Access Compliance Report

Public Rights-of-Way

| Intersection ID: 8500 | Main Street: ERIE_ST | Cross Street: LASALLE_ST | Location: NW |
| ADA ID: C9F4409C861D | Ramp Type: PerpDiag | Initial Pass/Fail: Fail | Overall Compliance: No |

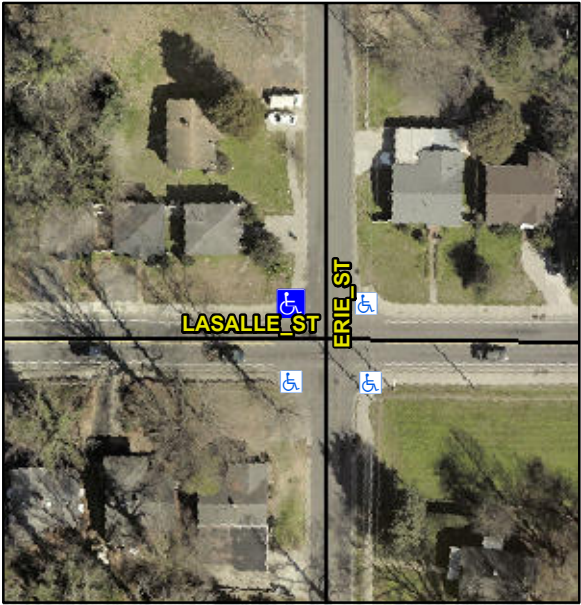
| Codes/Mitigation Info/Possible Solution | | | Field Measurements/Component Compliance | | |
|---|---|--|---|--------------------------|-------------|
| <p>Surveyor Notes:</p> <p>N/A</p> <p>PROW/ADA:</p> <p>Not Found, R304.5.1, R304.2.2, R304.5.3</p> | | | No | Ramp Length (in) | 59.5 |
| | | | No | Ramp Width (in) | 34.0 |

| Codes/Mitigation Info/Possible Solution | | | Field Measurements/Component Compliance | | |
|---|---|--|---|--------------------------|-------------|
| | Remove & Replace Curb Ramp With Two New Directional Ramps or Equivalent. | | Compliance | Description | Data |
